# FREQUENTLY ASKED QUESTIONS

January 2024

AMATS: Spenard Road Rehabilitation  
Minnesota Drive to Benson Boulevard Project

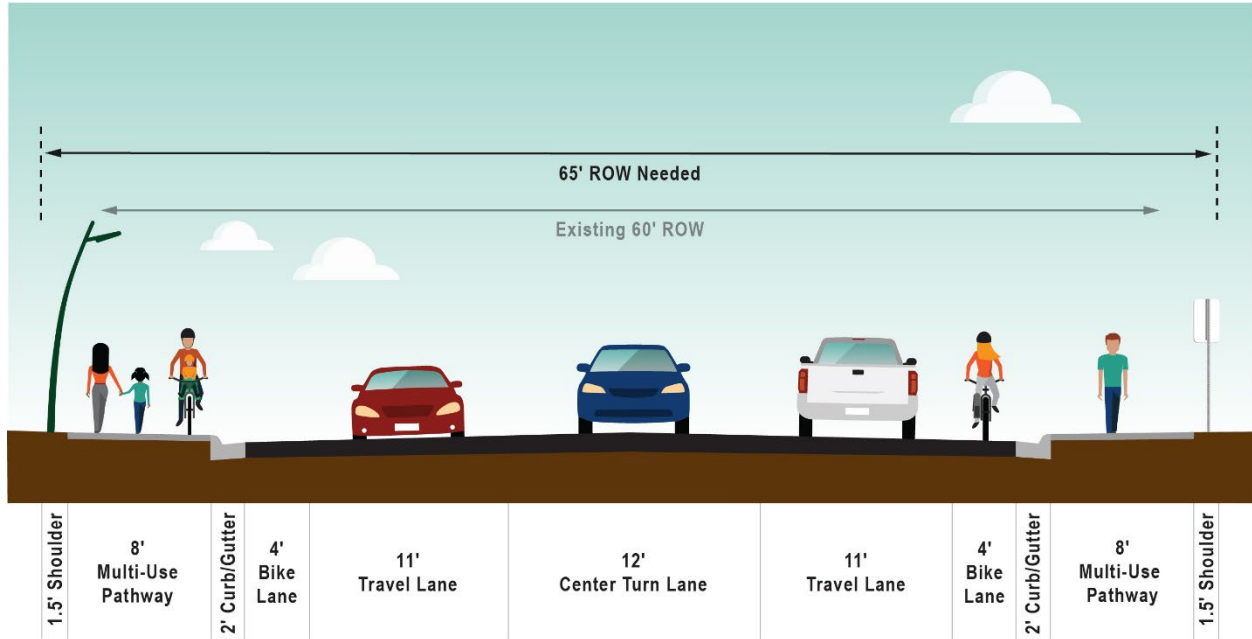
### What will the road look like?

### How does a three-lane typical section handle traffic compared to a four-lane typical section?

### What is the width of the center left turn lane on this segment of Spenard Road?

The typical section is shown below.

Research indicates a three-lane roadway can handle similar traffic volumes to a four-lane roadway (up to 20,000 vehicles per day), with a comparable or even improved level of service. This was observed following the completion of the “road diet” reconstruction on Arctic Boulevard, and the project team expects a similar outcome following construction of this project. Current volumes on the corridor are approximately half of the upper limit for three lane facilities.

The current design has a 12-foot center left turn lane. This is below the minimum MOA Design Criteria dimension of 14 feet.
